OFFICE OF THE CHIEF COMMISSIONER

Safety recommendation: *AIC 19-R20/18-1002*

Addressed to: Avions de Transport Regional (ATR) Limited

AIC assessment of BEA response to *Recommendation AIC 19-R20/18-1002* issued to Avions de Transport Regional (ATR) Limited.

Attachment 1: Electrical Smoke Checklist

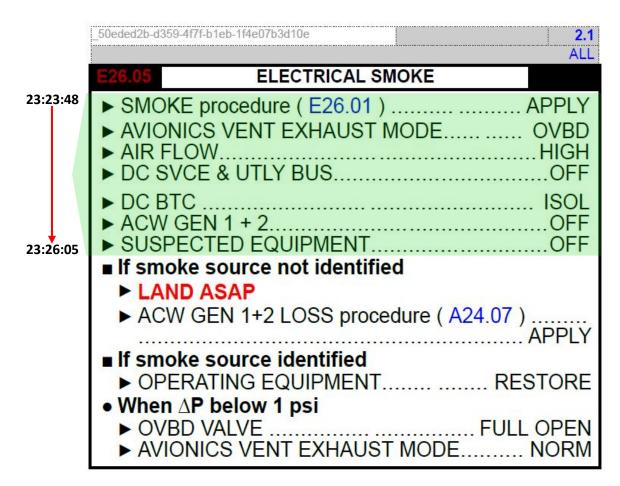
When the electrical smoke warning activated, the flight crew referred to the ATR *Quick Reference Handbook* (*QRH*) '*Electrical Smoke*' checklist (See Attachment 1). The first action item on the checklist required them to refer to the '*Smoke*' checklist (See attachment 2).

The electrical smoke warning had given the crew the impression that the source of the smoke was in the avionics/electrical compartment, leading them to hastily read through the memory action items of the 'SMOKE' checklist that they had partially completed. With this pre-conception, the crew returned to the Electrical Smoke checklist as soon as they got to the action item, 'SMOKE SOURCE...IDENTIFY' of the 'SMOKE' checklist. The 'Note' contained in the 'SMOKE' checklist was not consulted. The checklists were carried out in a disjointed and incomplete manner.

The crew continued with the '*Electrical Smoke*' checklist, switching off a number of essential aircraft systems, including both *Alternating Current Wild generators (ACW Gen 1 and 2)*, which caused the hydraulic system power loss. They also isolated the *direct current bus tie contactor (DC BTC)* which caused the DC bus 2 network to lose power completely when the No. 2 engine was shutdown.

The investigation determined that under the existing circumstances, the crew actioned the incorrect checklist, due to a confirmation bias induced by the ambiguous electrical smoke warning.

An extra line of defence may have existed if a *CAUTION* note was ergonomically included in the *Electrical Smoke* checklist.

The PNG Accident Investigation Commission (AIC) recommends that ATR should ensure that a '*CAUTION*' statement with content similar to the content of the 'Note' in the '*QRH Smoke*' checklist is included in the '*QRH Electrical Smoke*' checklist.

Attachment 2: Smoke Checklist (Emergency)

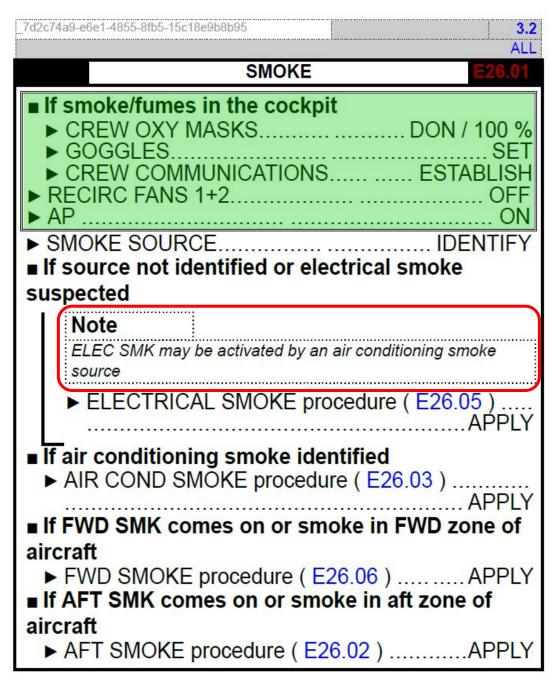
AIC Notes: Memory items identified by bold border commencing at '*If smoke/fumes in the cockpit*' Pale green highlighting added by the AIC to identify the areas of checklist completed. Red border around **Note** added by the AIC to highlight the area of safety deficiency concern.
